**DOCUMENT 00 91 02
ADDENDUM NO. 2**

PROJECT: 2024 Smith and Spillane MS Renovations
BID DATE: **Thursday, February 20, 2025 (no Change)**
FROM: Carolina Weitzman, A.I.A.
Natex Corporation Architects
447 Heights Blvd, Houston, TX 77007
TO: **Prospective Bidders**

SMITH MS

1 TECHNOLOGY DEMOLITION FLOOR PLAN - LEVEL 1 - AREA D
 Scale: 1/8" = 1'-0"

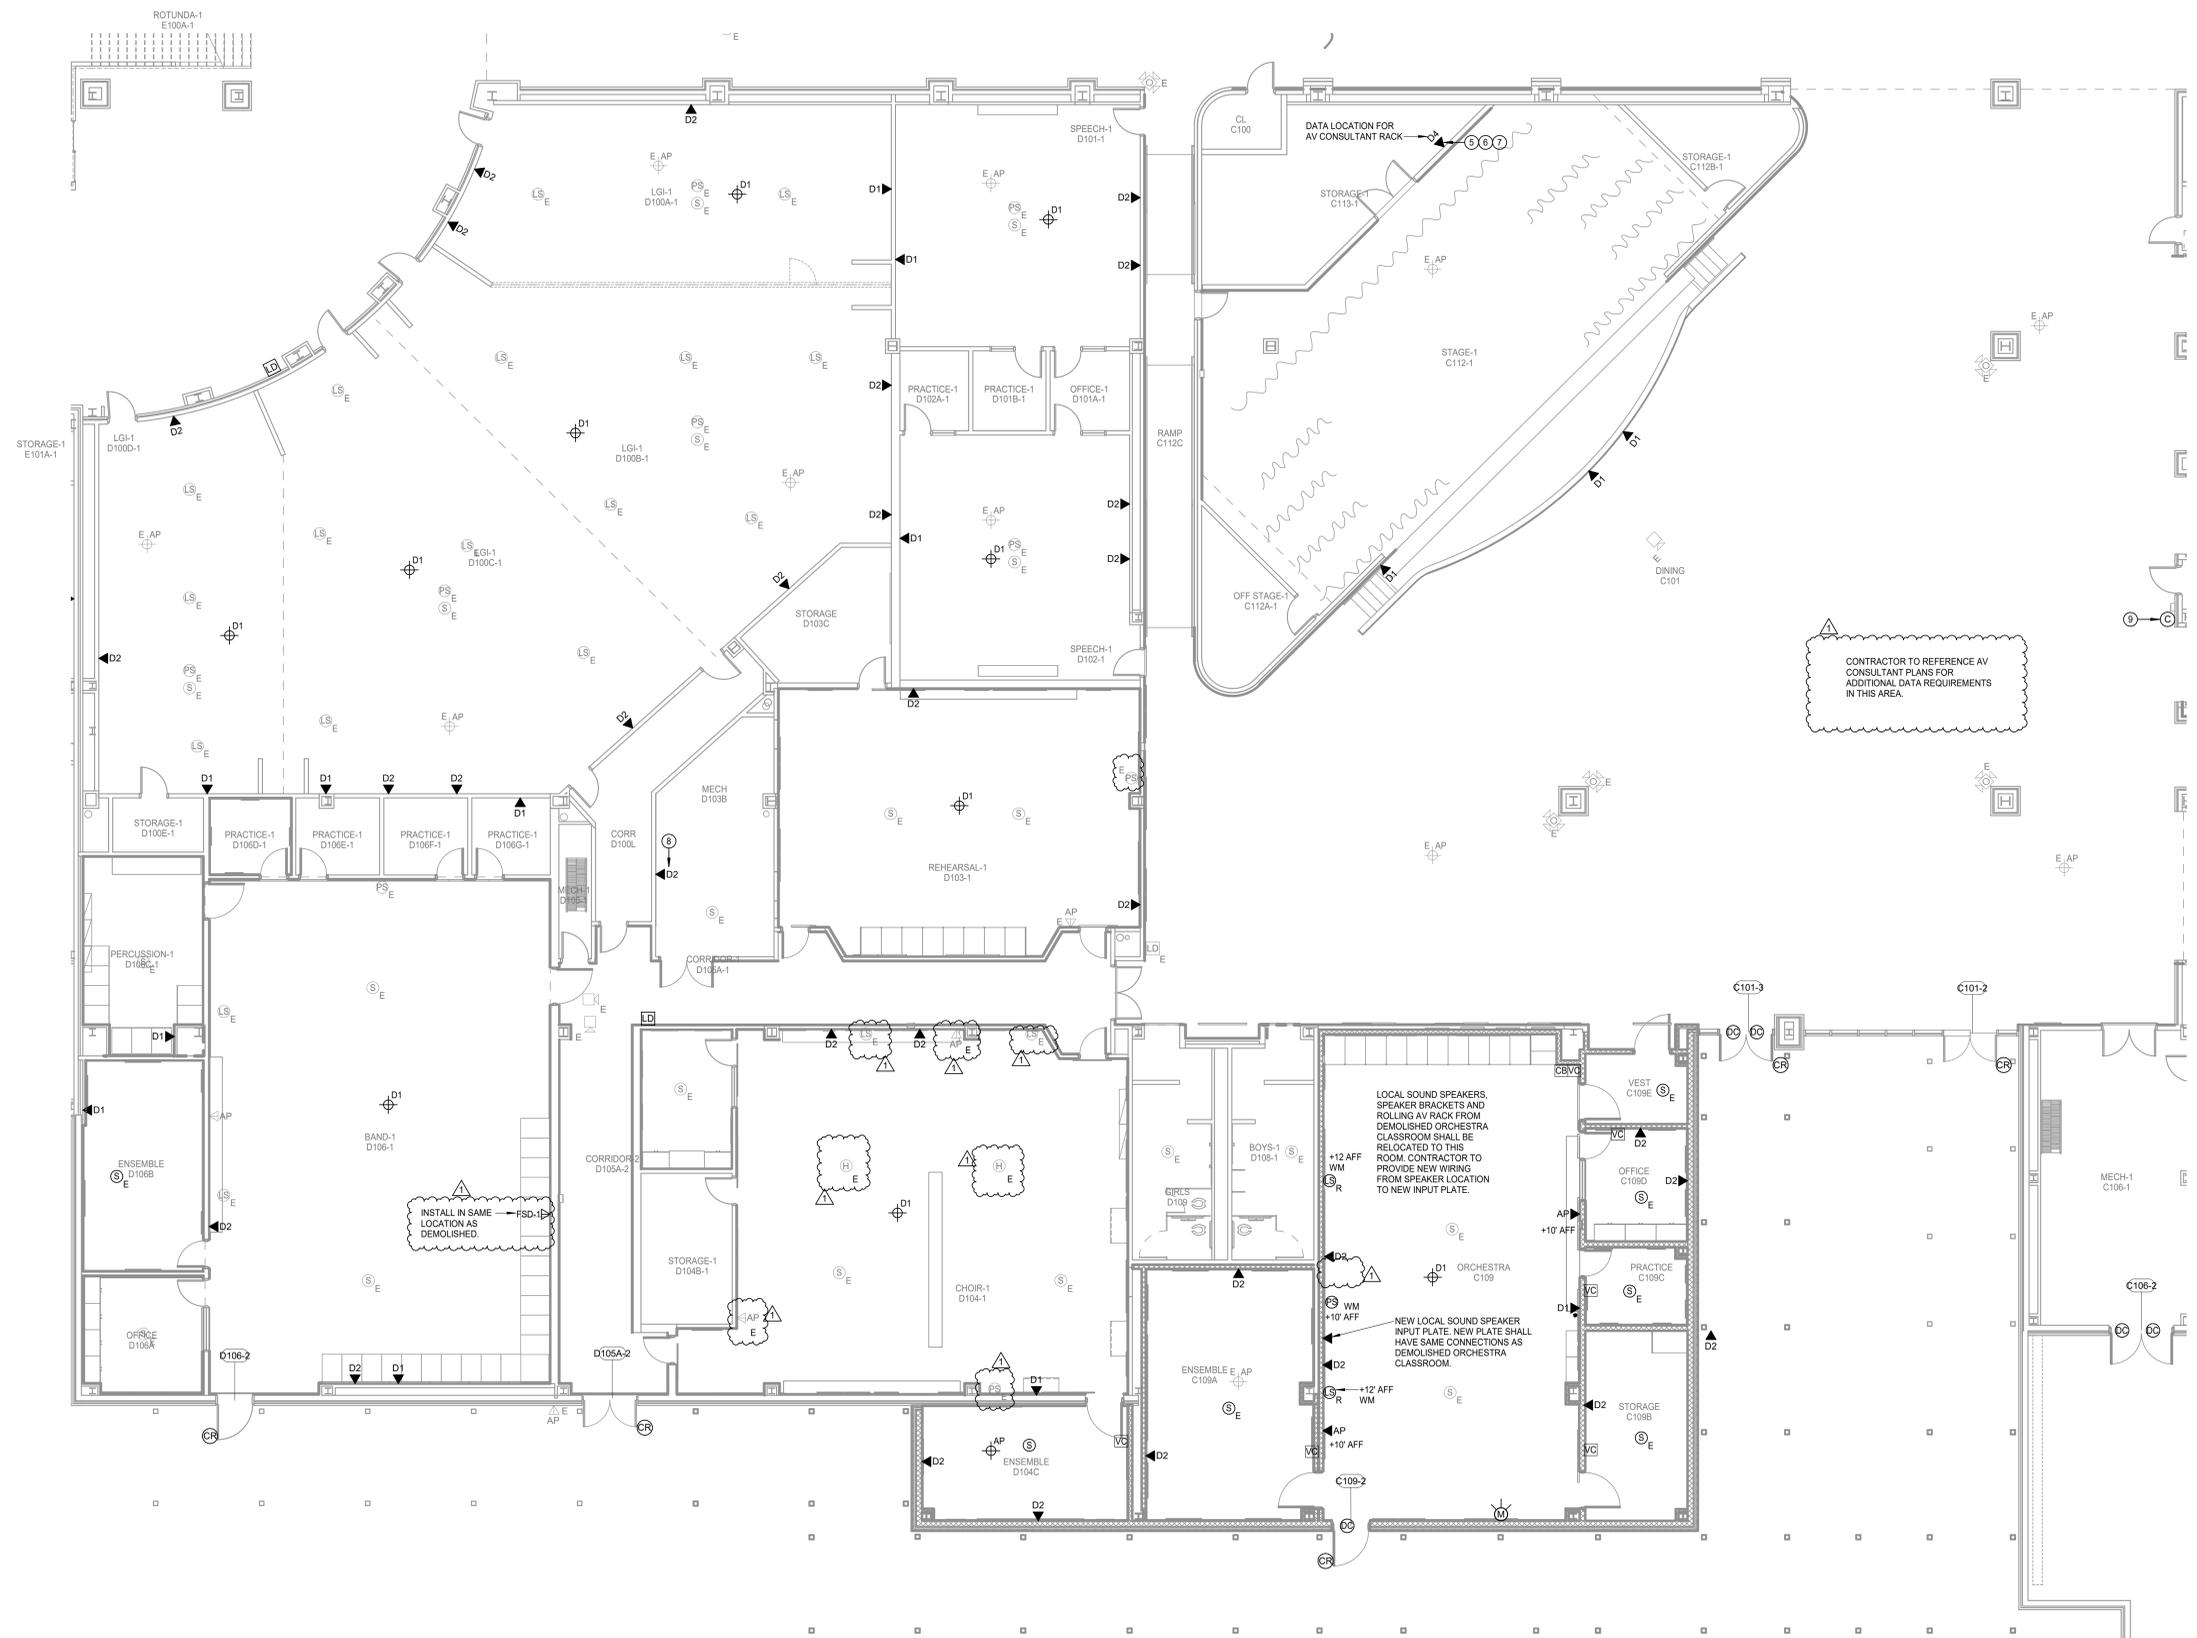
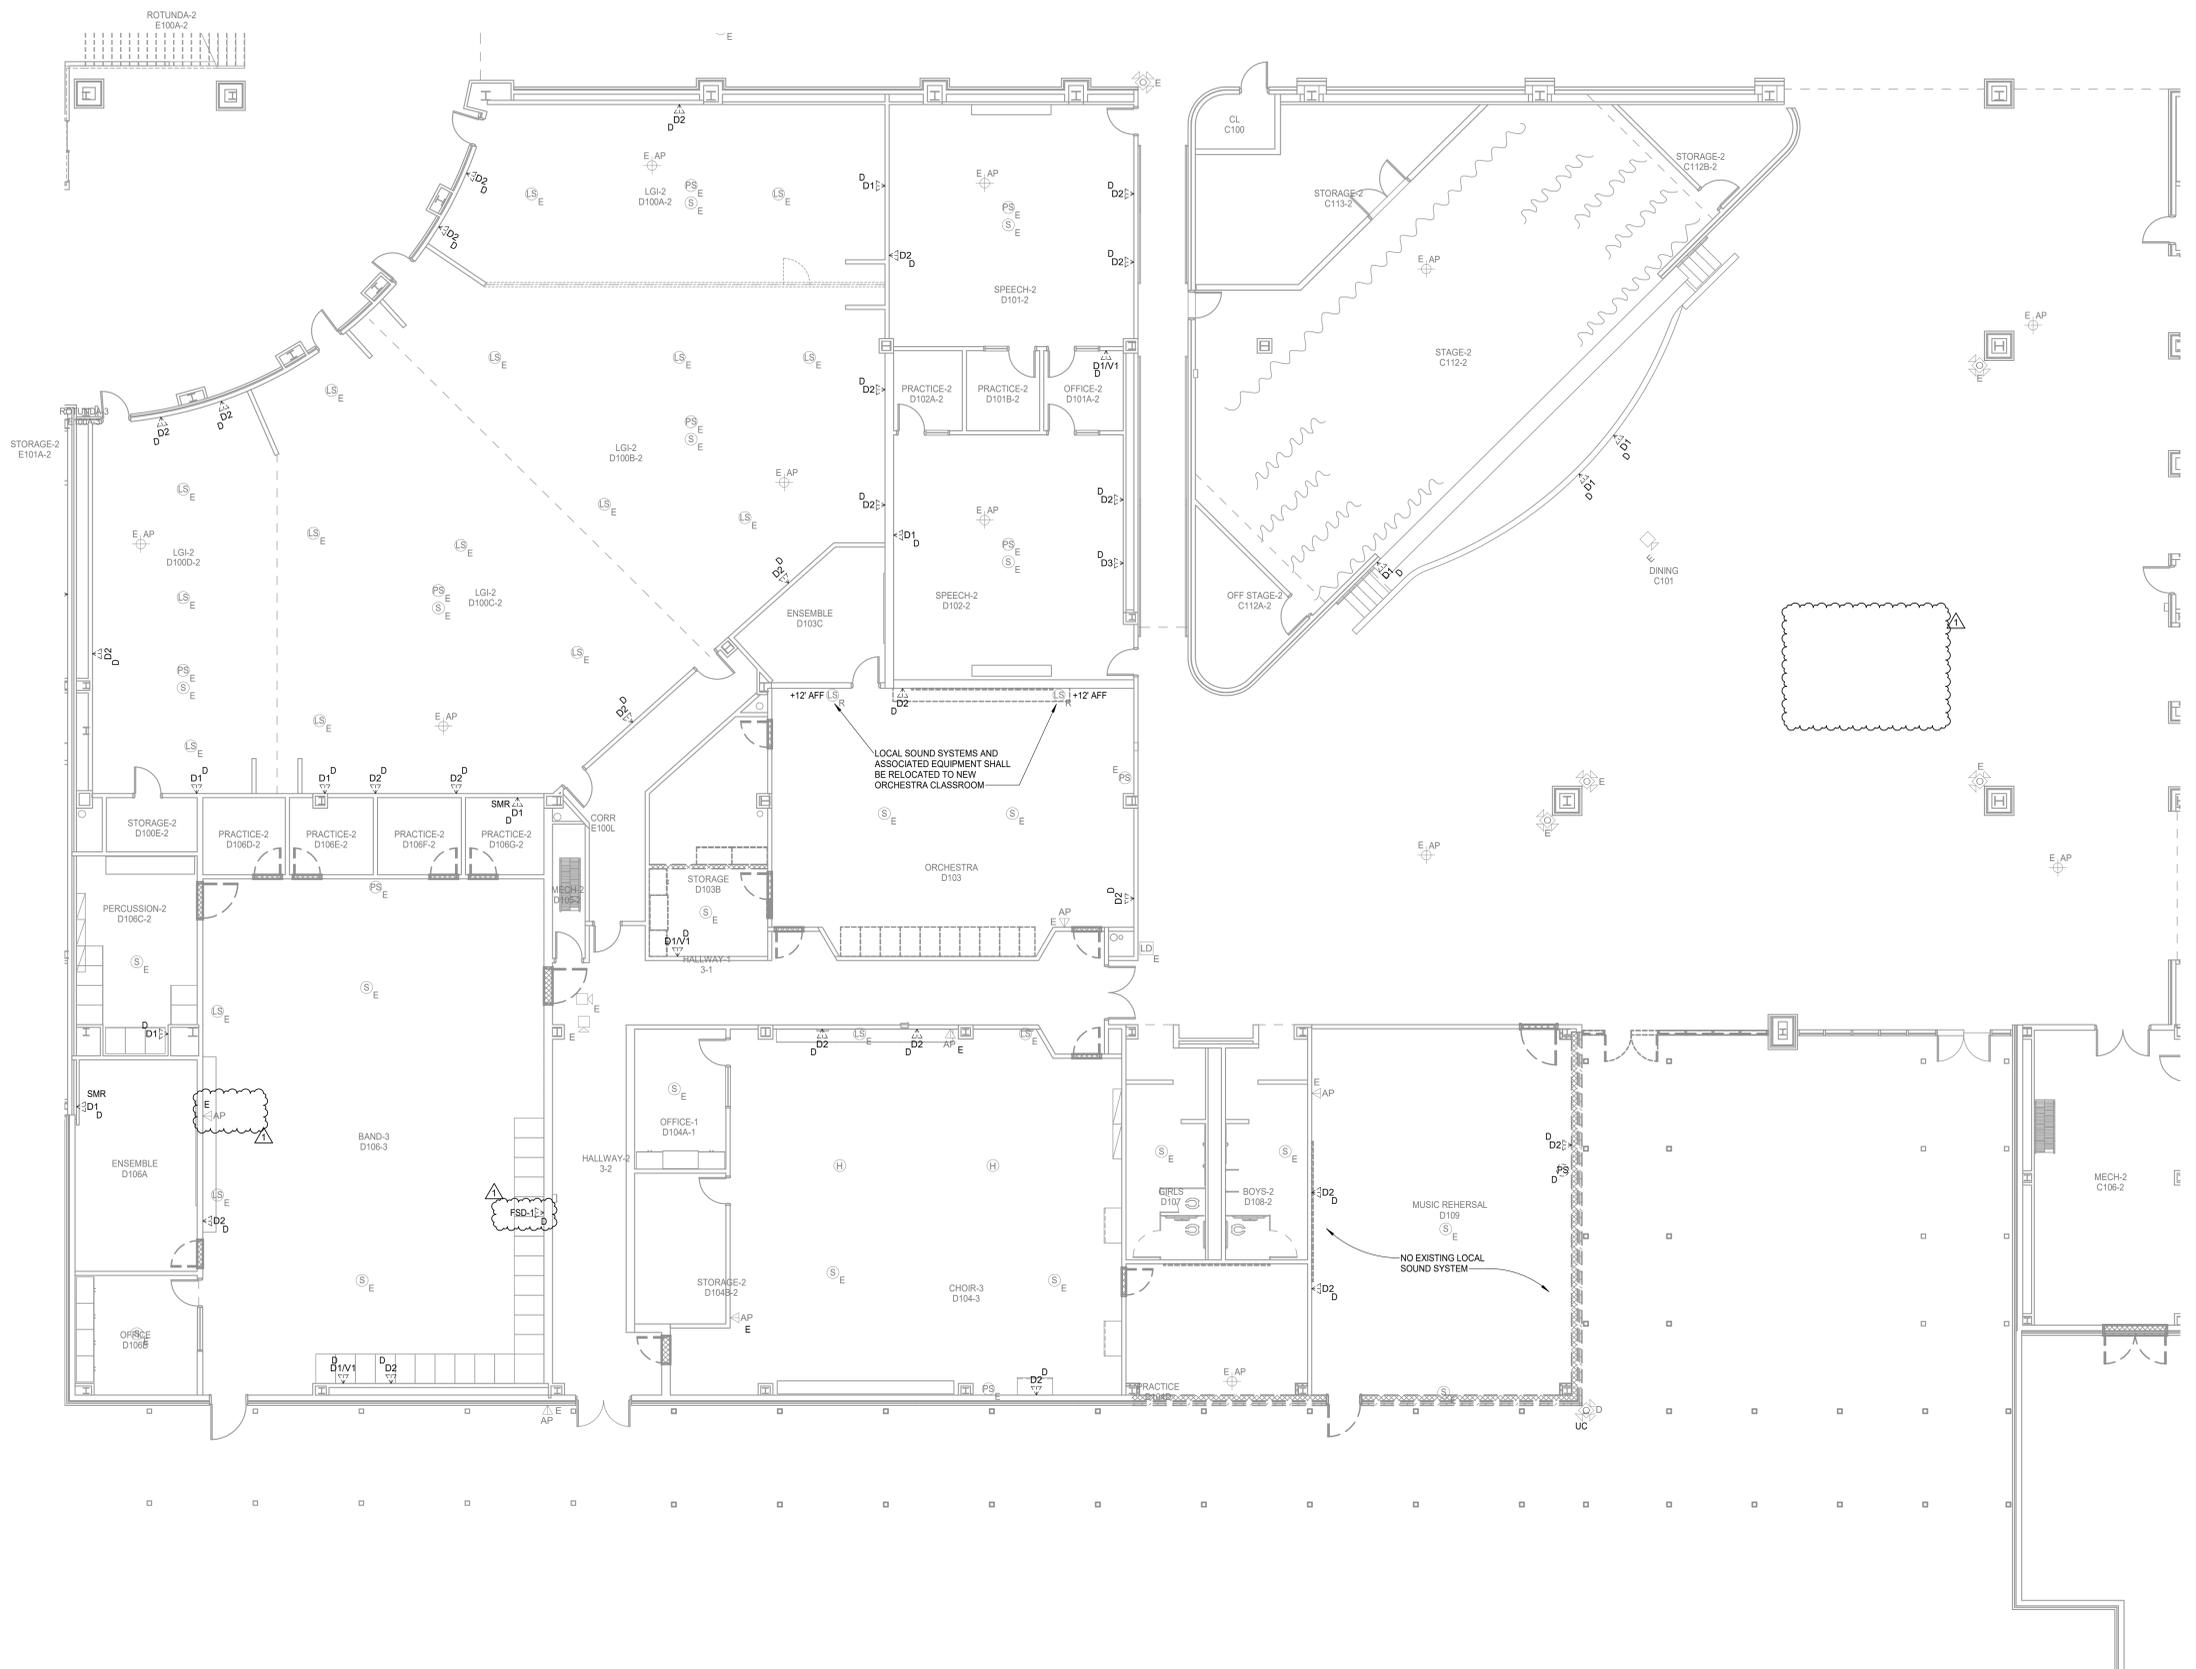
- a. Refer to revised sheet for clarifications to demolition scope in cafeteria and band hall.
38. T2.04 - TECHNOLOGY FIRST FLOOR PLAN – AREA ‘D’
 - a. Refer to revised sheet for scope clarifications in Band, Choir and Cafeteria.

4 | DOOR STATION - KITCHEN DOOR

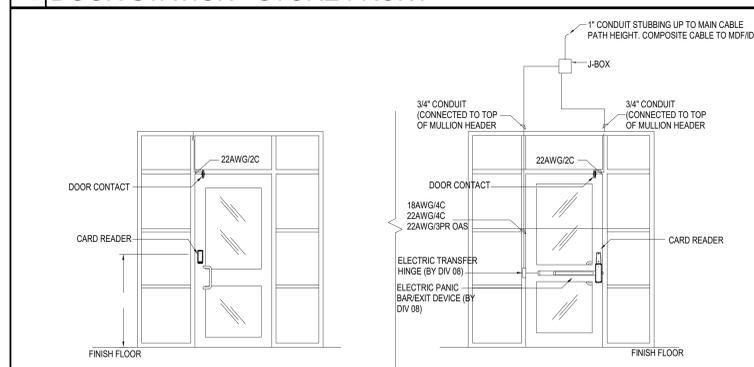
39. T5.05 – TECHNOLOGY DETAILS
 - a. Refer to revised sheet for changes to kitchen door access control.

Project Number: 23073
Date: 26 JANUARY 2025
Drawn By: WHL / KLO
RECEPTION PLANS & DETAILS
A3.01

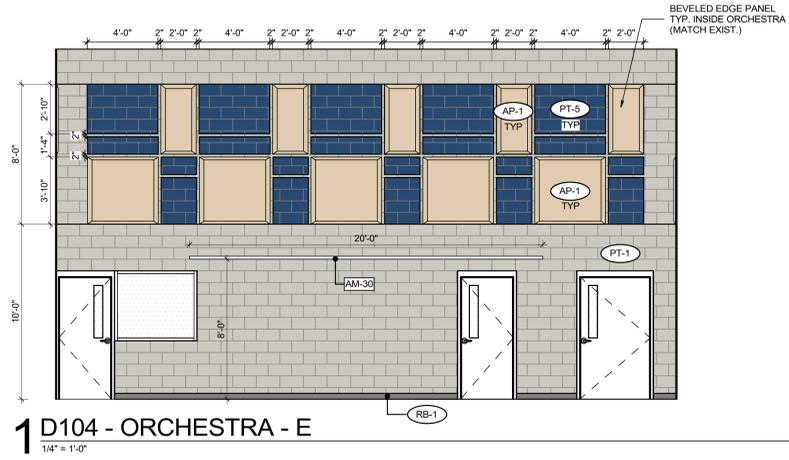
3. A3.01 – RECEPTION PLANS & DETAILS
 - a. Detail 7 Reception elevation – Clarify dimensional sign design.
 - b. Refer to revised sheet.

Project Number: 23073
 Date: 26 JANUARY 2025
 Drawn By: WHL / KLO
 ELECTRICAL
 DEMOLITION FIRST
 FLOOR PLAN - AREA 'A'
E0.01

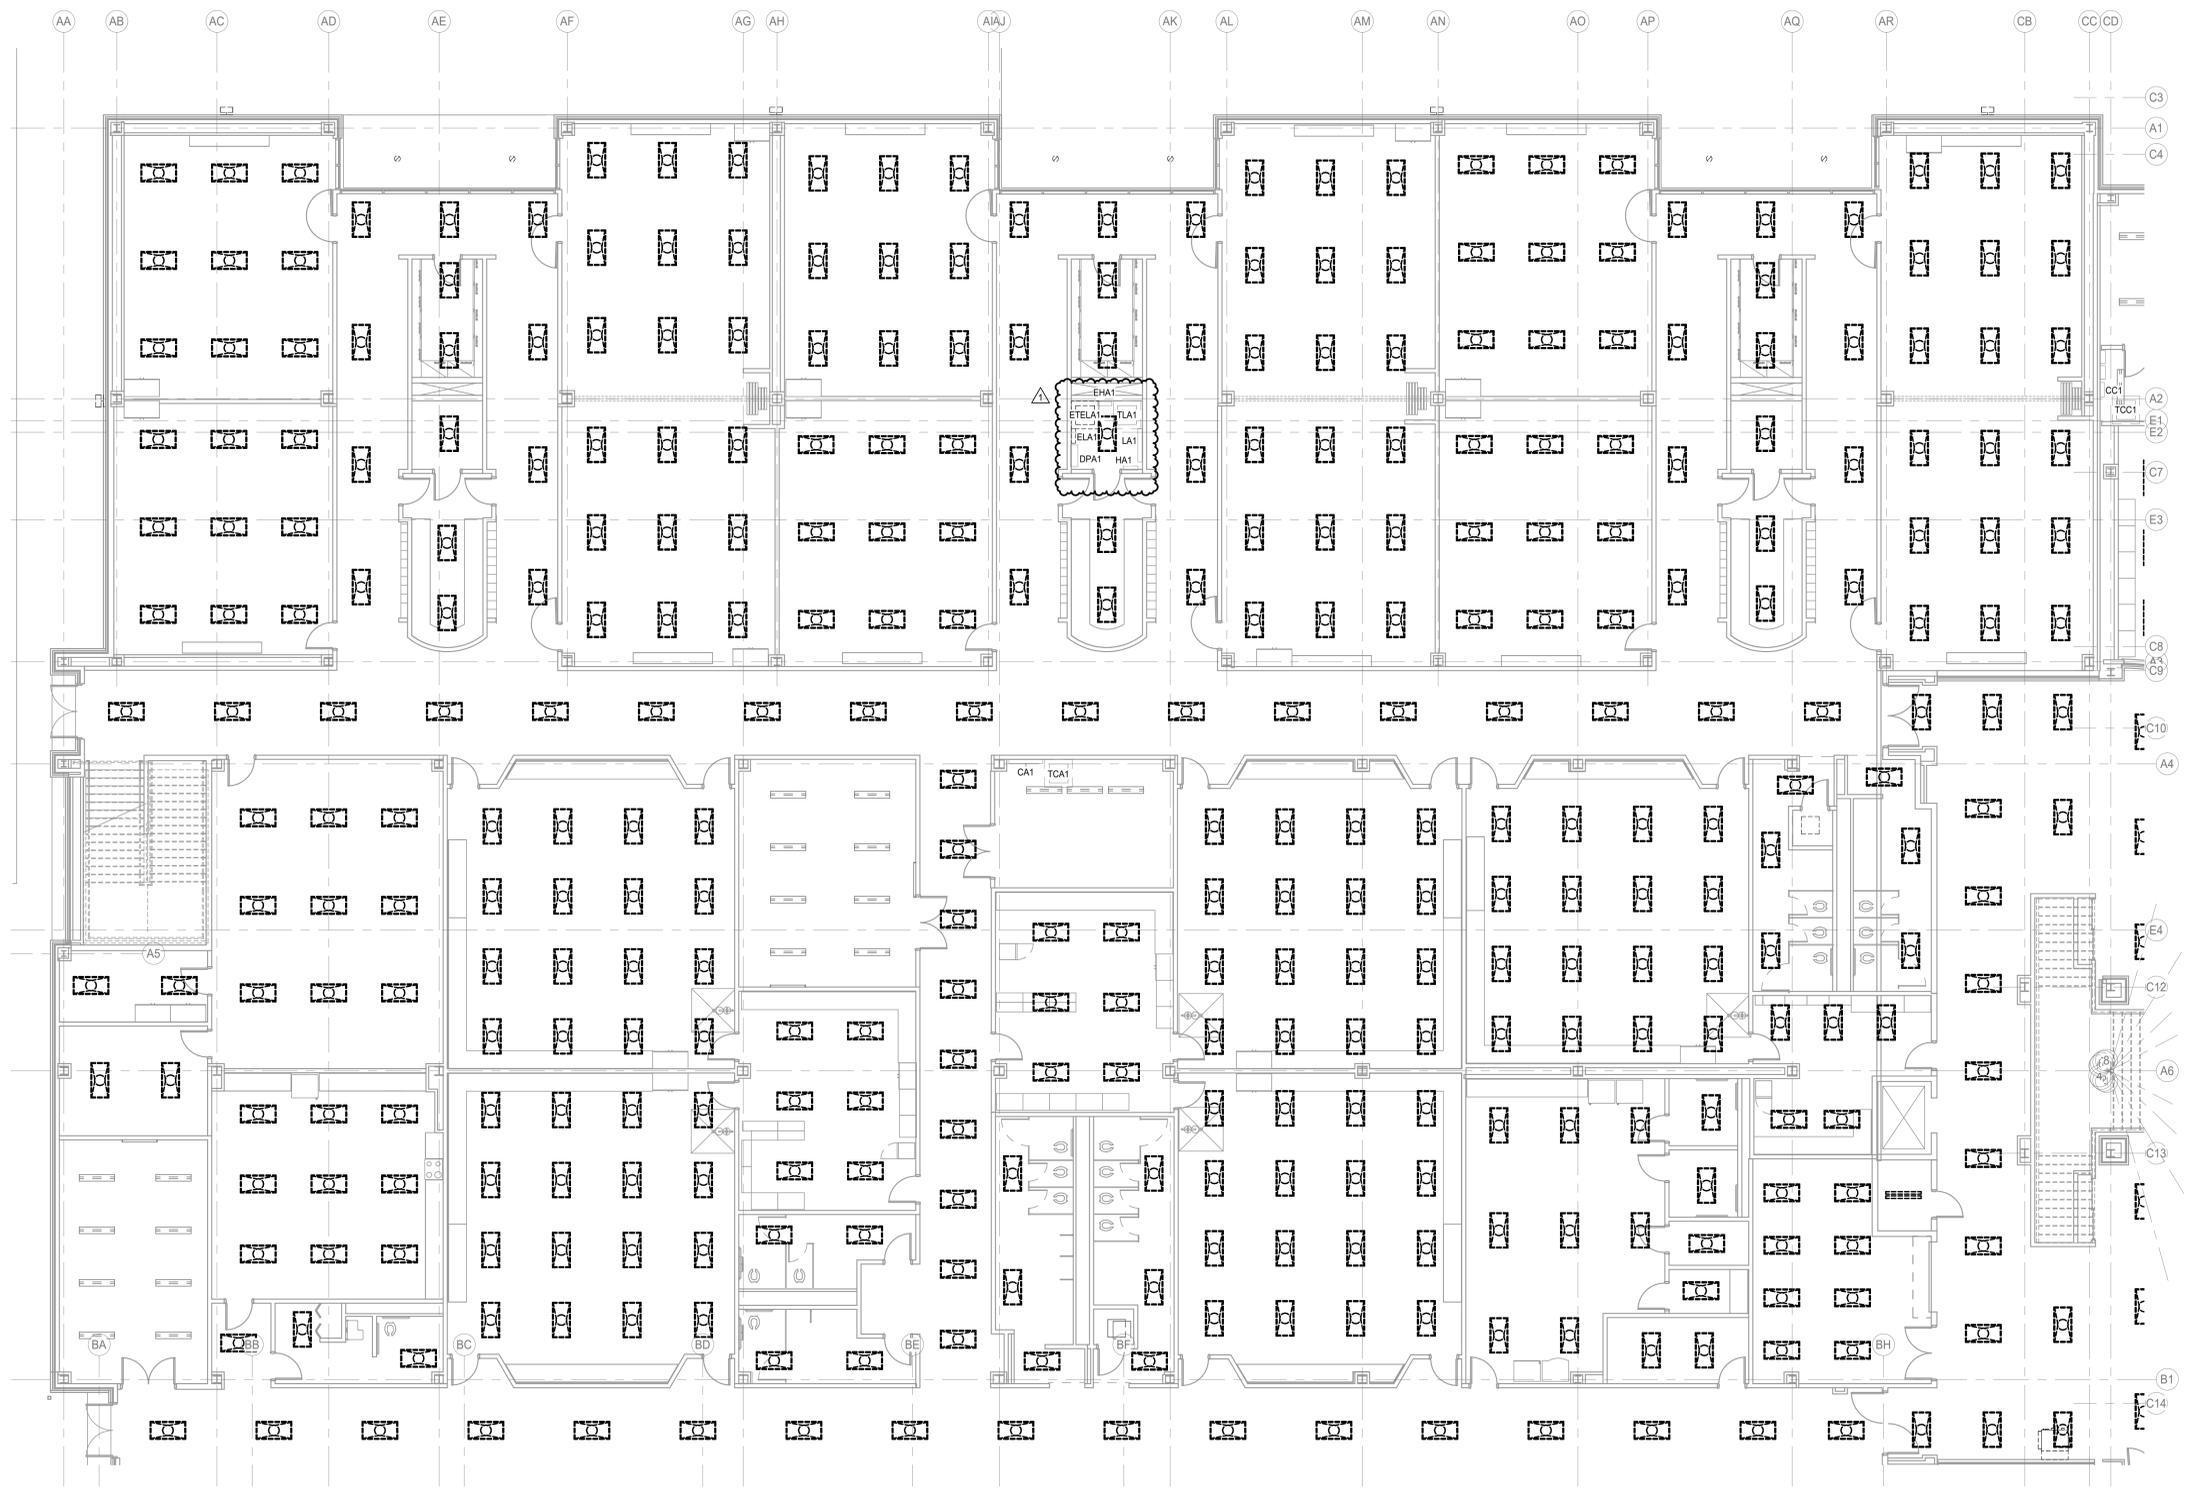
12. E0.01 – ELECTRICAL DEMOLITION POWER FLOOR PLAN -LEVEL 1 -AREA A
 - a. Show TELA1 and ELA1 as demolished equipment.
13. E2.04 – ELECTRICAL LIGHTING FLOOR PLAN – LEVEL 1 – AREA D
